From: [Bill Mclean](#)
To: [Lindsey A. Oskoui](#)
Cc: [Seth Mearig](#); [Tim Riley](#); [Harris Kaffie \(hakaffie@gmail.com\)](mailto:hakaffie@gmail.com); [Pablo Martinez](#)
Subject: FW: Kaffie Tract Land Plan
Date: Thursday, August 6, 2020 1:18:48 PM
Attachments: [image001.jpg](#)
[image002.gif](#)
[Little Barton Creek-Option "J-1" \(30 Lots\).pdf](#)

From: Pablo Martinez <PMartinez@bgeinc.com>
Sent: Friday, July 31, 2020 2:58 PM
To: Tim Riley - Riley-McLean Land (twr@rileymclean.com) <twr@rileymclean.com>; Bill Mclean <bmclean@mcleanhowardlaw.com>
Cc: Seth Mearig <SMearig@bgeinc.com>
Subject: Kaffie Tract Land Plan

KAFFIE TRACT
PRELIMINARY LOT LAYOUT

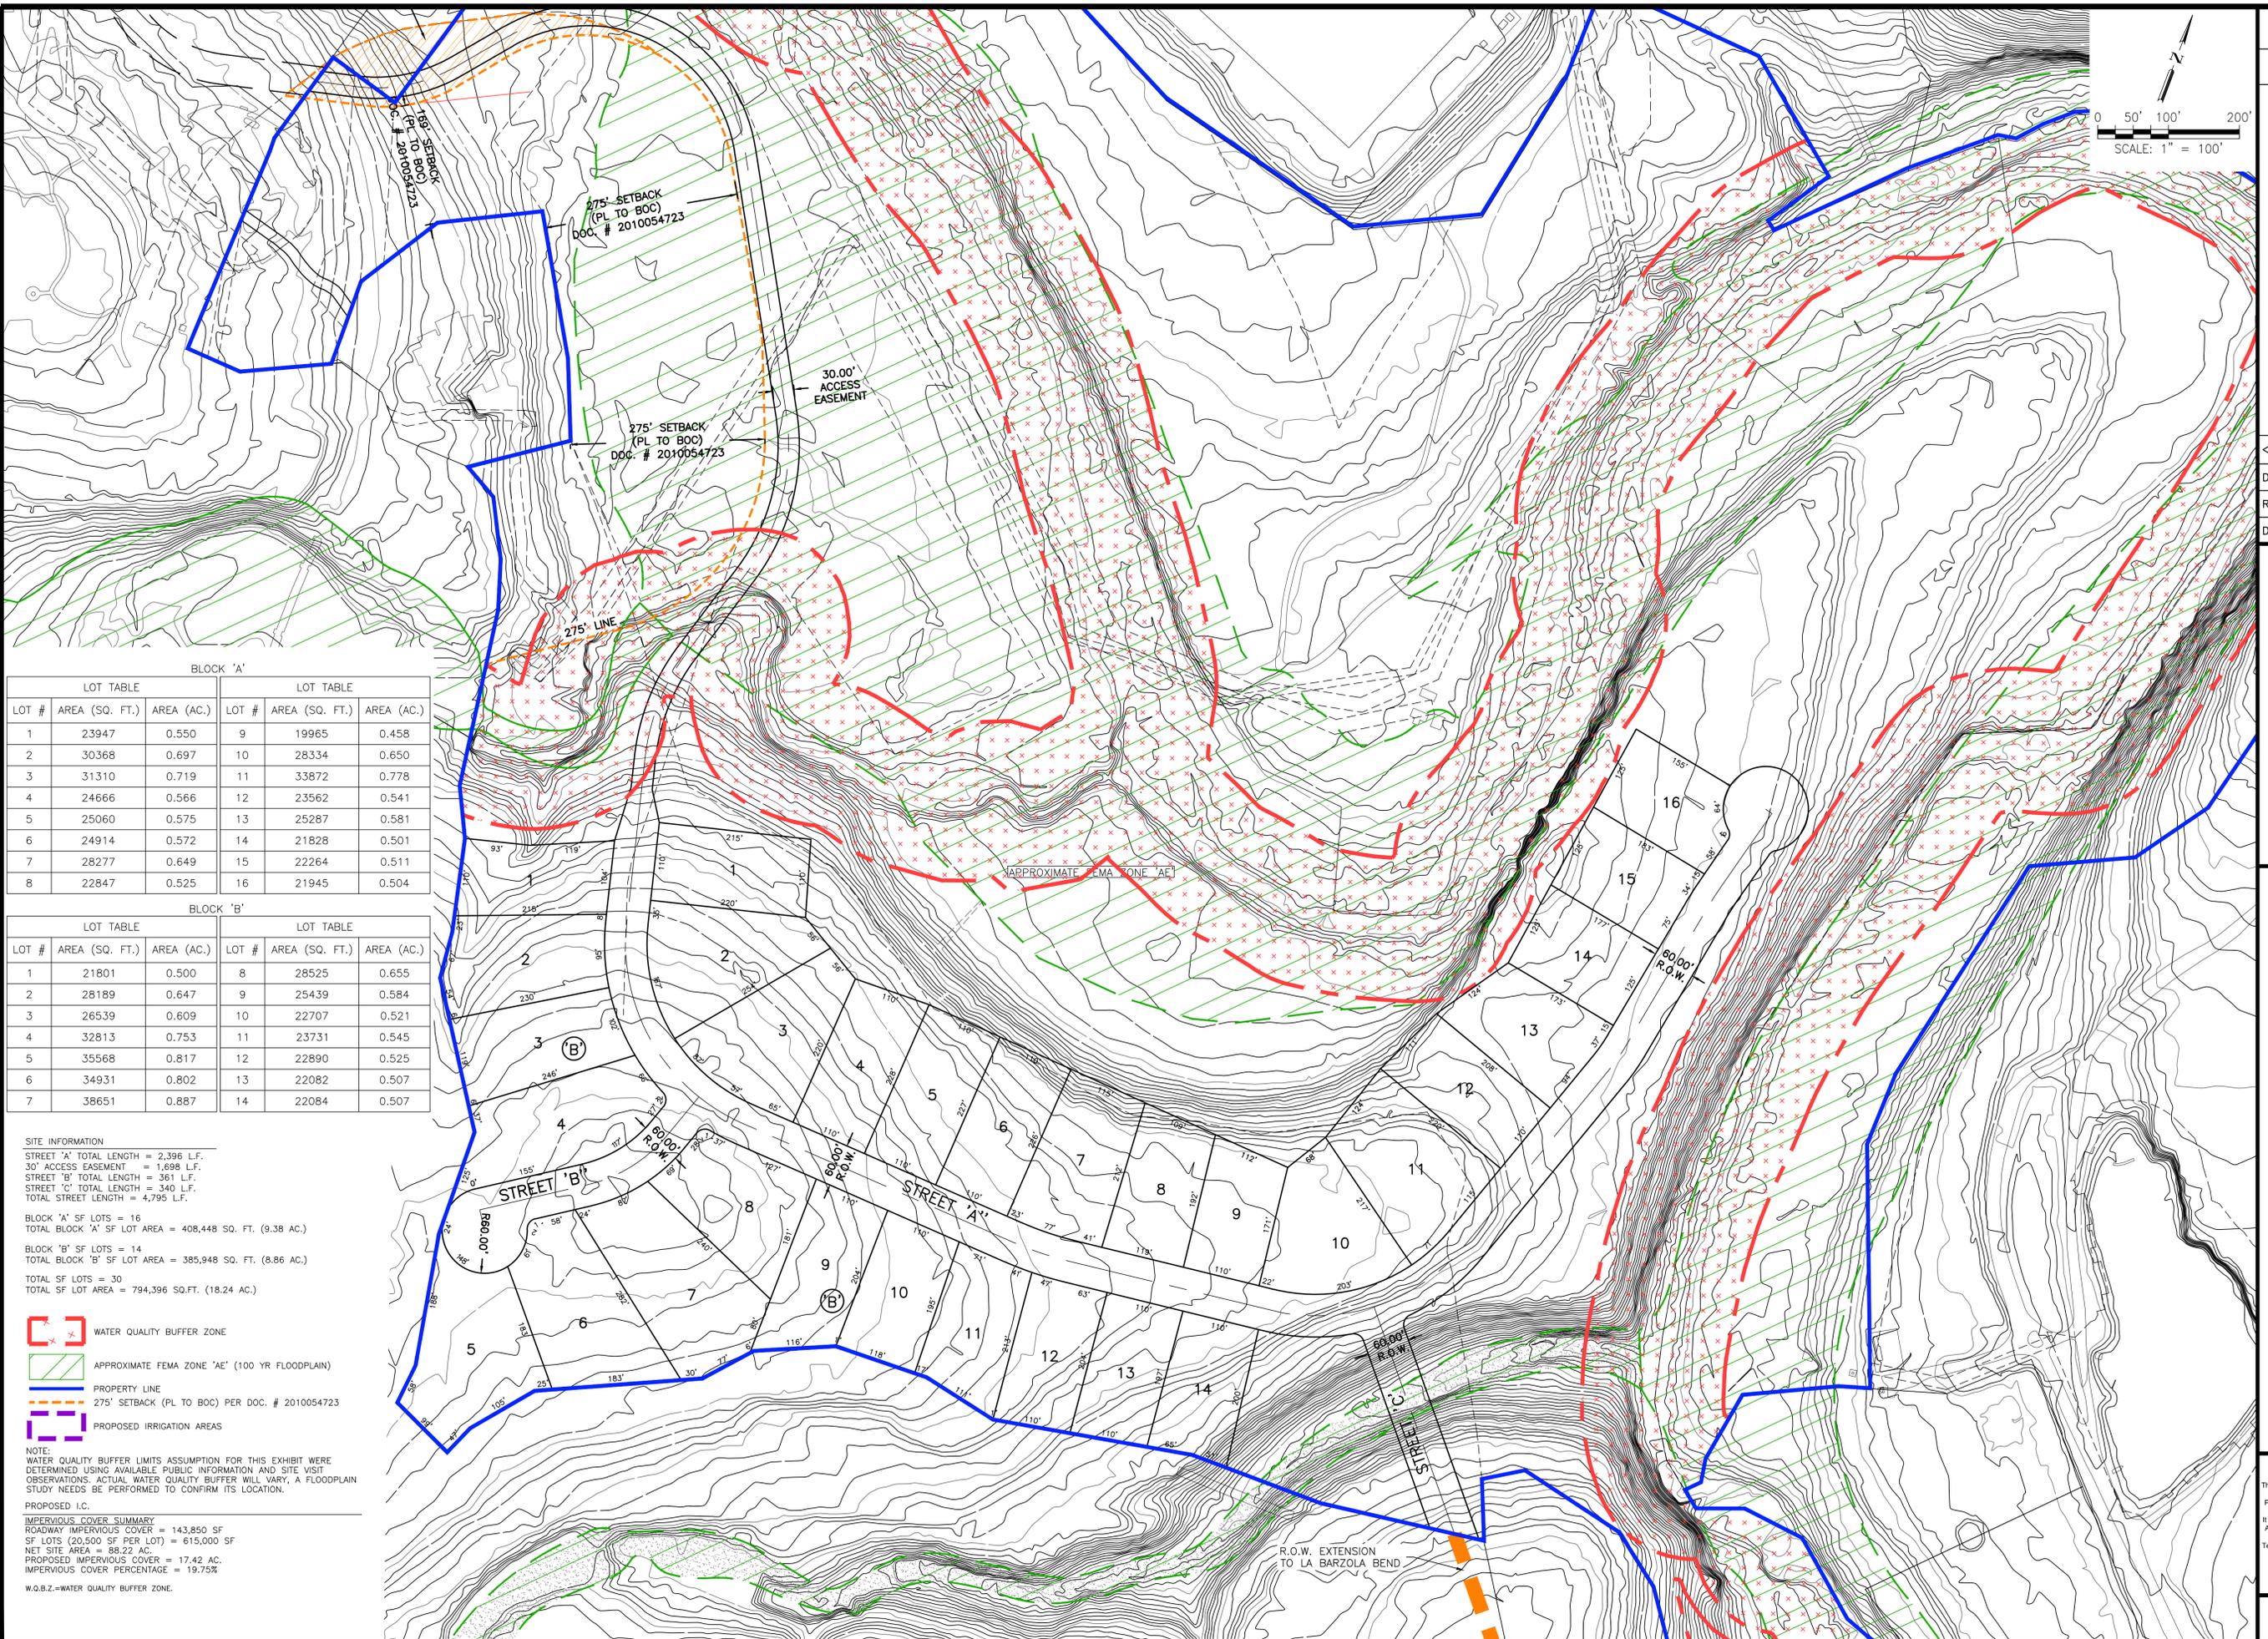
We will require a variance from this requirement as neither of the two proposed access points to the development are public collectors or arterial streets.

We will require a variance from this requirement as the maximum block length on Street A is 2,396 ft.

Street A from Street C Intersection to the East will be considered a Cul-De-Sac Street, in the current land plan this street exceeds the 600' cap (840')

Due to the site location and topographical constraints there are no feasible connections to any public collectors or arterials.

Due to the site location and topographical constraints it is not possible to provide a roadway stub to breakdown block length. There are no roadways to provide connection to.

Same reason as above, due to the site location and topographical constraints it is not possible to provide a roadway stub to cul-de-sac road length. There are no roadways to provide connection to.
